INDESIT company

Model type:
AVXL109EU

Commercial code:
F029624

n1040306: Reduction of cabinet depth on ARISTON EVOII 6kg washing machines produced at Bre

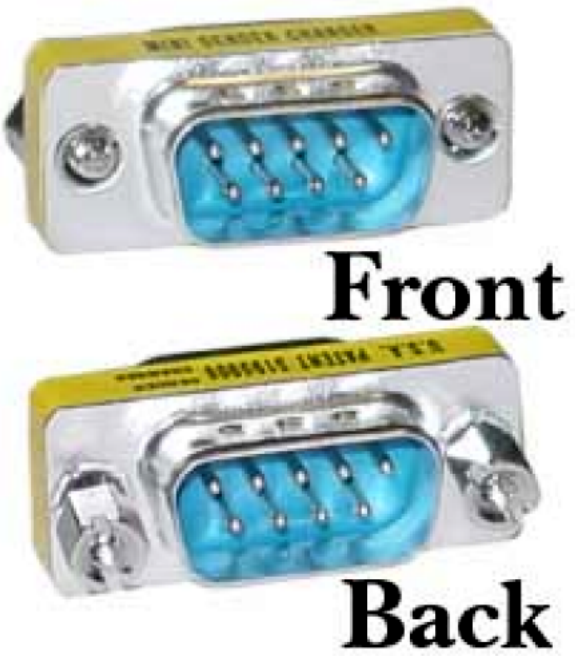
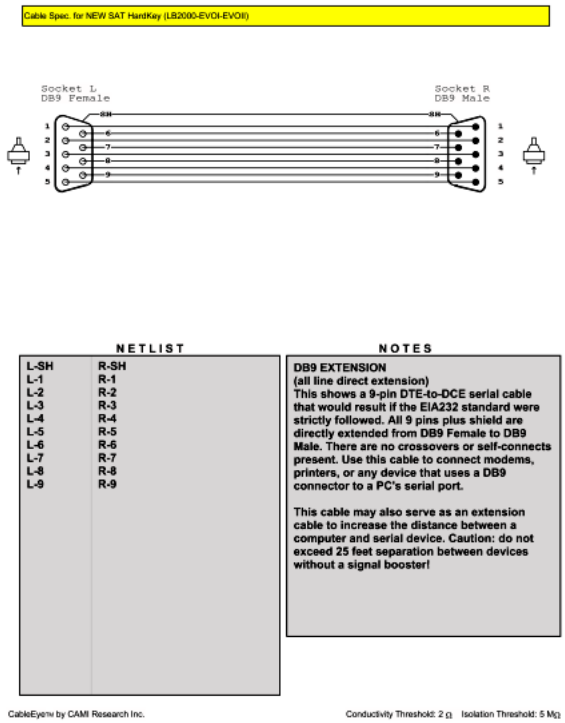
From serial no. 30915.0001, ARISTON EVOII 6kg washing machines affected by this note have been modified due to the reduced depth of the cabinet.
The modified models have a new industrial code.
The items affected by the modification are: cabinet, packing kit, top, product dispenser lid (including solenoid valve) and

solenoid valve.
Regarding the packaging kit, top, product dispenser lid and solenoid valve, the Replacements Warehouse will continue to manage premodification and new parts.
The premodification cabinets will be managed while stocks last, after which, in case of cabinet replacement the new cabinet, top and solenoid valve must be used, referring to the spare parts list for the relevant model.
Given below is a list of models affected by the modification with relevant new and premodification parts:

Packing kit: premodification 095741, new 094777;
Top: premodification 095738, new 097710;
Product dispenser lid (including solenoid valve): premodification 095740, new 097711;
Solenoid valve 1E2U: premodification 095739, new 097712.

Fig. n10402231

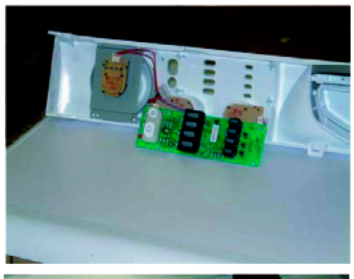
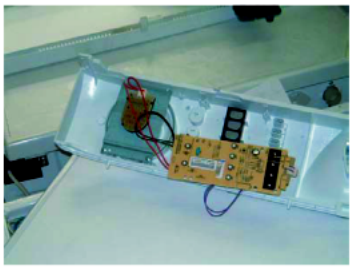
From serial no. 40429.0001, models AVL, AVXL, AVSL, AML have been equipped with a new panel with well holes for the ON/OFF and RESET buttons and flush plastic light diffusers in place of the projecting siliconed ones (see picture n10402231 Fig.02). These features determine whether an appliance is modified or premodification.
The modification has also involved the electronic card whose panel and display communication connectors are on the left and not at the back (see picture n10402232 Fig.2).

For both models
C00143338 - LED CARD EVOII AVL /BUILT-IN ARISTON
C00110115 - WHITE BUTTONS ON-OFF/RESET EVOII LED KIT
C00109854 - PANEL WIRING LBE EVOII
C00110055 - SILICONED BUTTONS AVL-AVSL
C00110059 - PANEL WIRING -DISPLAY 240000848B2.
C00111227 - WIRING MAIN - DISPLAY 24000084804B1 (POLARIZED).
The new parts are only interchangeable with the pre-modification ones if used altogether. They are not individually interchangeable.

n1040381: Drain pump with bayonet-style filter - front Loading Brembate

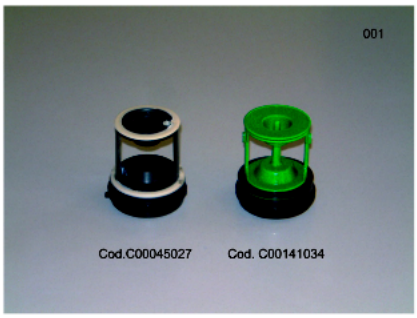
From serial no. 50720.0001 a new drain pump with bayonet-style filter has been installed on all front loading washing machines manufactured in Brembate.

New parts:
C00119307 - Drain pump
C00141034 - Pump filter kit

Premodification parts:
C00092264 - Drain pump
C00045027 - Pump filter kit

The new parts can be used instead of premodification ones.

n4008f00: Thermic link wire removed on three-phase motor

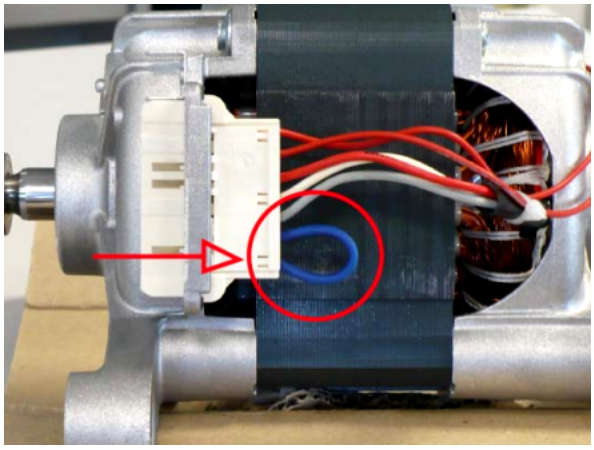
Attention!
When you assist the premodification models using the new motor code you MUST use the thermic link wire code C00265838.

In the attached image you can see the fixing of thermic link wire in the motor therminal box.
